NRC 2001-0019

DOCKETS 50-266 AND 50-301  
RESPONSE TO REQUEST FOR ADDITIONAL INFORMATION;  
SUPPLEMENT 2 TO TECHNICAL SPECIFICATIONS CHANGE REQUEST 219  
ADOPTION OF PRESSURE AND TEMPERATURE LIMITS REPORT  
AND REVISED P-T AND LTOP LIMITS  
POINT BEACH NUCLEAR PLANT, UNITS 1 AND 2 (TAC NOS. MA8459 AND MA8460)

DOCKETS 50-266 AND 50-301

PROPOSED PRESSURE TEMPERATURE LIMITS REPORT  
REVISION 2

FIGURE 2  
RCS PRESSURE-TEMPERATURE LIMITS FOR COOLDOWN

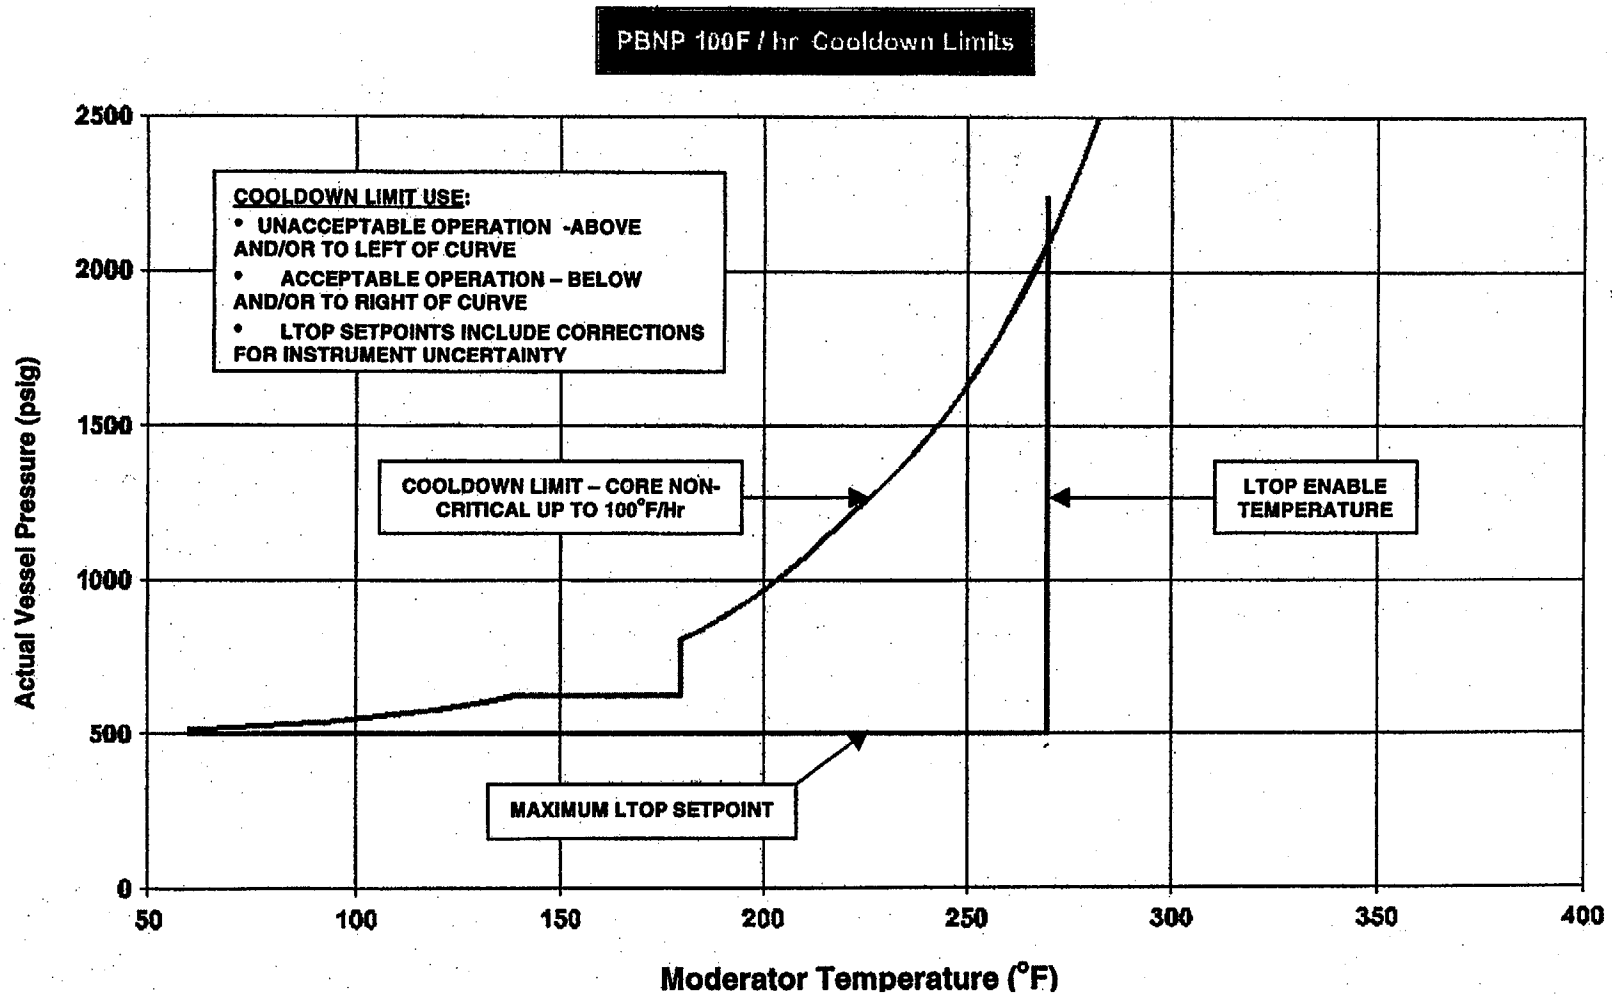
4. The Safety Evaluation (Attachment 2 to the March 10, 2000, amendment request) states that, for PBNP, Units 1 and 2, a single setpoint is established based on the most limiting reactor vessel beltline materials at the minimum allowable pressure for the RCS pressurization established pursuant to Appendix G to 10 CFR Part 50.

Clarify the above statement with “minimum” allowable pressure, which is inconsistent with the “maximum” allowable pressure in PBNP Calculation 2000-0001.

Response – The intent of this statement is to communicate the following information:

A single set point is established for both PBNP Unit 1 and 2. The setpoint is derived using the most limiting reactor vessel beltline material.

The value of maximum calculated pressure from an LTOP transient is smaller than the allowable value [i.e., lowest (or “minimum”) point] on the cooldown limit curve.

Appendix G to 10 CFR 50 is satisfied since the maximum calculated pressure from a LTOP transient is lower than the pressure limit on the limit curve.

In summary, the term “minimum”(minimum allowable pressure), as it was used in the March 10, 2000 safety evaluation, referred to the minimum point of the PBNP cooldown limits curve (where the curve asymptotically approaches 500 psig). Since this curve defines the maximum allowable pressure for operation, the intent of the statement is consistent with the “maximum” allowable pressure in PBNP Calculation 2000-0001.
